SUBJECT: RESPONSE TO ISSUES RAISED AT THE DECEMBER 12 CITY COUNCIL MEETING ON PLAN FOR JONES POINT PARK

SUBJECT: RECEIPT OF STAFF REPORT ON RESPONSES TO ISSUES RAISED AT THE NOVEMBER 18 PUBLIC HEARING ON THE URBAN DECK AND JONES POINT PARK

SUBJECT: RECEIPT OF REPORT ON THE WOODROW WILSON BRIDGE PROJECT PLANS FOR JONES POINT PARK AND THE URBAN DECK AND SETTING THE REPORT FOR PUBLIC HEARING ON SATURDAY, NOVEMBER 18 AND COUNCIL CONSIDERATION ON TUESDAY, DECEMBER 12

Interim Park Improvements Plan

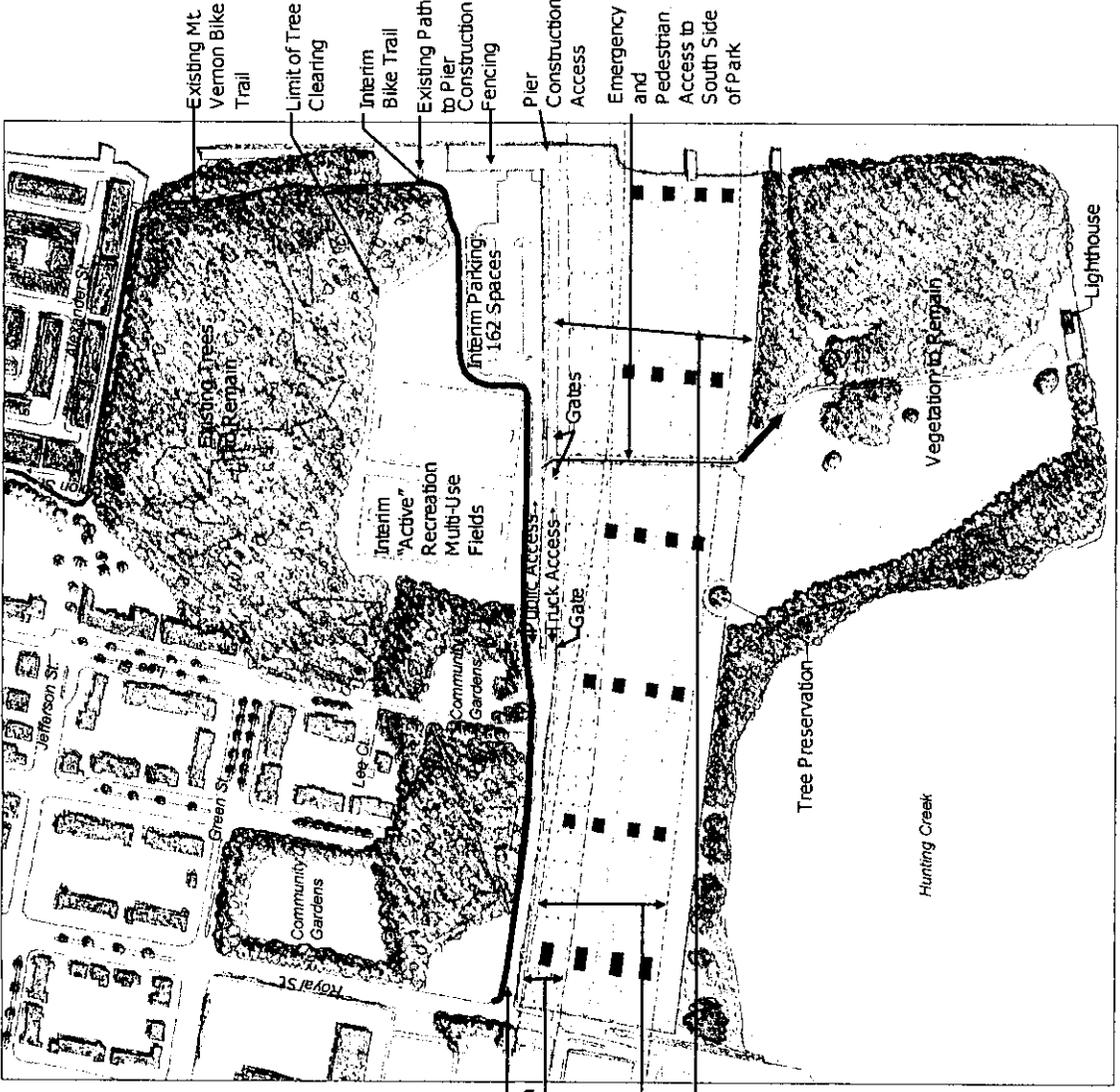
- (1) Approve the interim plan for Jones Point Park (Attachment 2 to the October 24 memorandum), with the understanding that the two athletic fields (and possibly the parking spaces) shown in the interim plan will be modified to accommodate the retention of the woodland area that is described in Recommendation 2.

In addition to approving the 65% design for the Jones Point Park, Council also needs to approve an interim (during construction) plan for the park. The proposed interim plan (Attachment 2) shows the athletic fields in the approximate location of the fields in the final design. The interim fields would be smaller, but the north and west boundaries would remain constant in both designs. In the final design, the athletic fields would expand to the south in the area presently occupied by the Jones Point Park road and the current bridge. To the east, the interim plan shows a 162 space parking lot to replace the parking lot currently at the west end of the bridge used by City employees. After the bridge construction is complete, this interim parking lot would be replaced with a tot play lot and additional trees, and parking for all cars would be under the bridge. It is important to note that if the interim plan is accepted, no more understory (limbing trees and removing underbrush) and trees will need to be removed than in the recommended final plan. The interim plan was presented at the Board and Commission meeting on August 14, the September 6 meeting at the Lyceum and was approved by the Park and Recreation Commission in September.
